DOCKET 50-255, LICENSE DPR-20
PALISADES PLANT, ANSWERS TO ALLOWABLE
TUBE WALL DEGRADATION ANALYSIS QUESTIONS

A number of questions have been raised by members of your staff concerning our February 12, 1976 submittal entitled "Analysis to Determine Allowable Tube Wall Degradation for Palisades Steam Generators."

FIGURE A

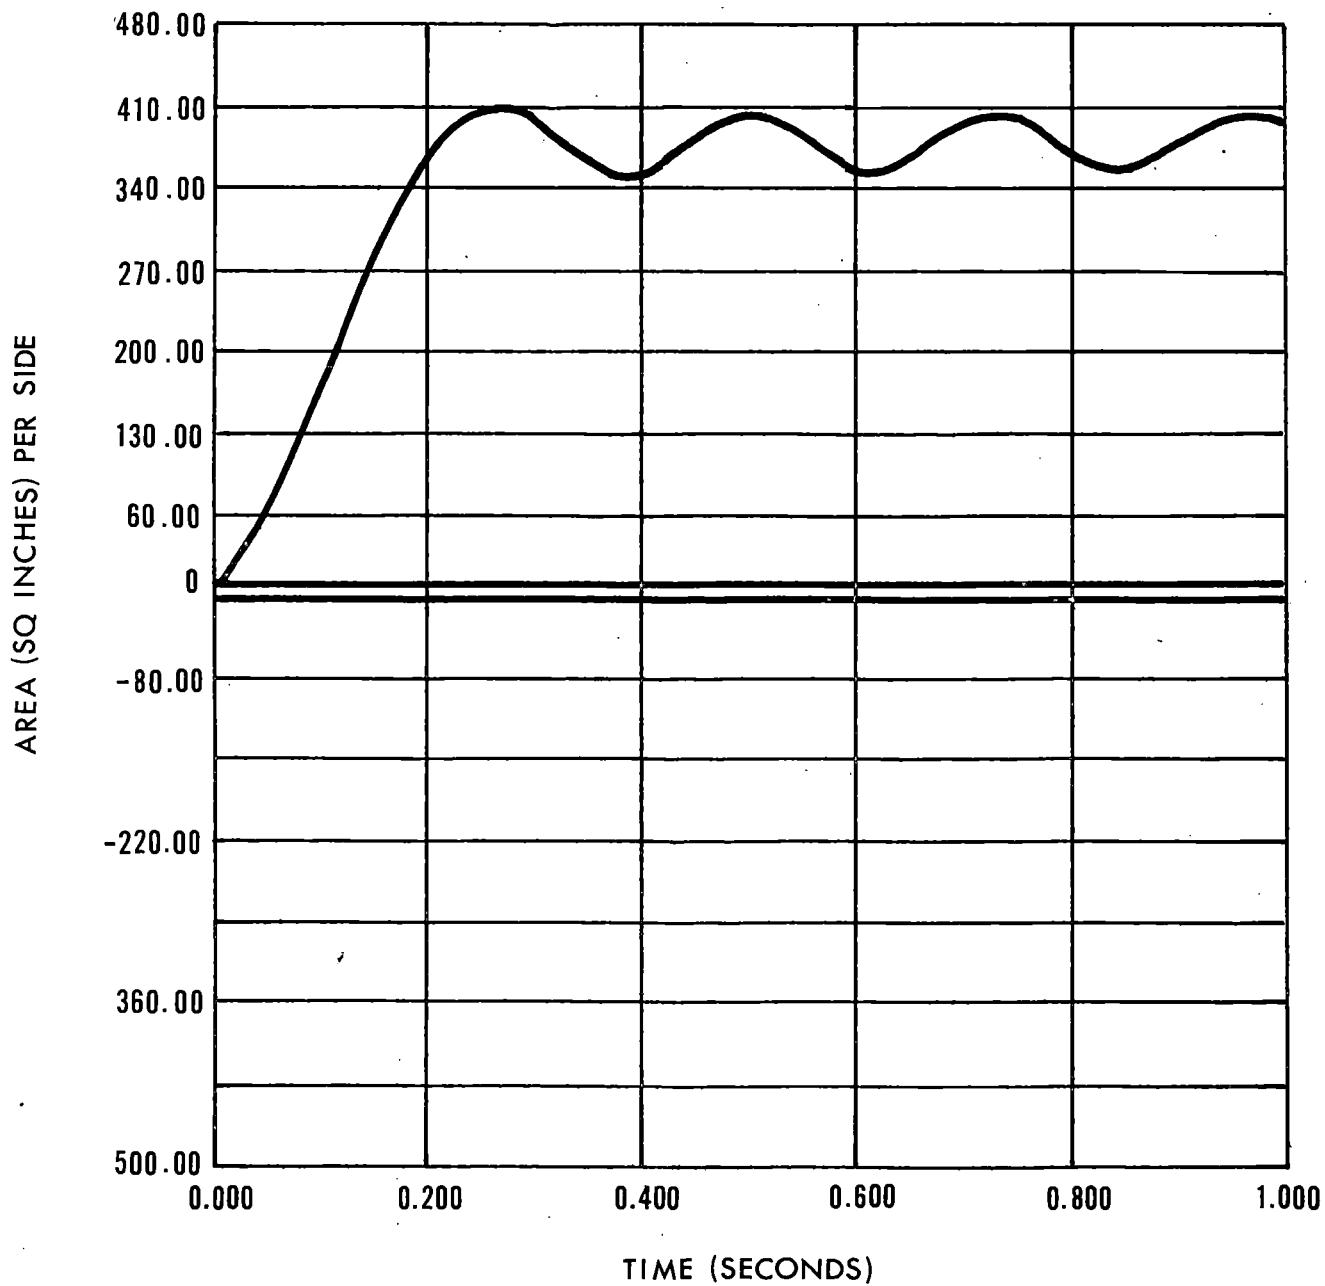
Justify the hot leg break area and break opening time, and discuss the sensitivity of the hydrodynamic load vs break area.

An elastic-plastic analysis was used to predict the movement of the hot leg pipe after a hypothesized guillotine break. This analysis had indicated that the relative displacements of the two severed ends of the pipe would be of such magnitude to make 425 square inches of area available for the escape of fluid.

In the original issue of "Analysis to Determine Allowable Tube Wall Degradation for Palisades Steam Generators," dated January 29, 1976, the break area considered for the hot leg pipe was 425 square inches. The resulting value of ΔP (rarefaction wave differential pressure) within the tube of interest was listed as 175 psi. The ΔP resulting from the full area break of the cold leg pipe was listed as 185 psi. Actually the 175 psi for the 425 square inch break in the hot leg is in error. The correct value is 152.8 psi. The ΔP for the full area break of the hot leg pipe (1385 square inches) is 173.8 psi. The ΔP values for hot leg break areas of 100, 425, 1000 and 1385 square inches are 57.6, 152.8, 172.2 and 173.8 psi, respectively. This indicates that even if the hot leg pipe were conservatively assumed to displace such that the entire area of 1385 square inches were available the resulting value of ΔP within the tube would be only 173.8 psi which is less than that which results from the cold leg break, which is 185 psi. In any case the cold leg break causes the largest energy loading on the tube.

With this in mind, the explanation of the details of the elastic-plastic analysis used to predict the severed hot leg pipe movement is not included in this submittal.

FIGURE C

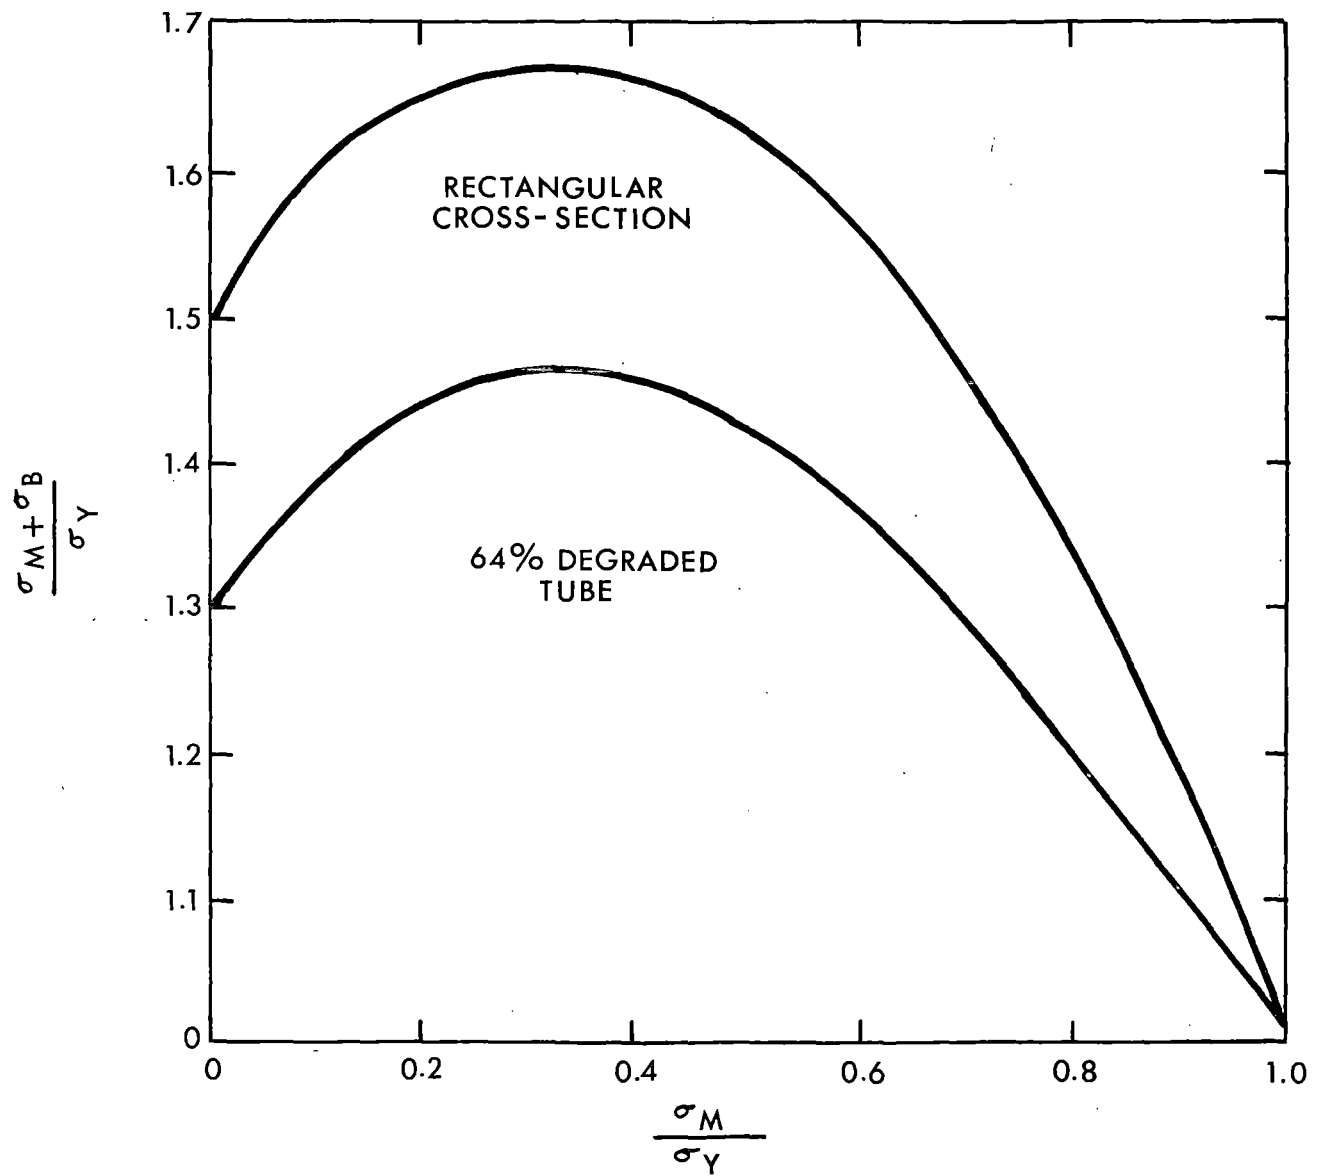
Provide a detailed discussion of the interaction curve as shown in Figure A.21.

The curves of Figure A.21 of Reference (2) define the combination of membrane and bending stress which will produce a complete plastic hinge for a healthy tube and a 64% degraded tube. The basis for these curves is consistent with the ASME Code Section III as defined in the "Criteria of Section III," Reference (3). The corresponding curve is presented for a rectangular section in Reference (3) and is reproduced in Figure C along with the curve for the 64% degraded tube for purposes of comparison.
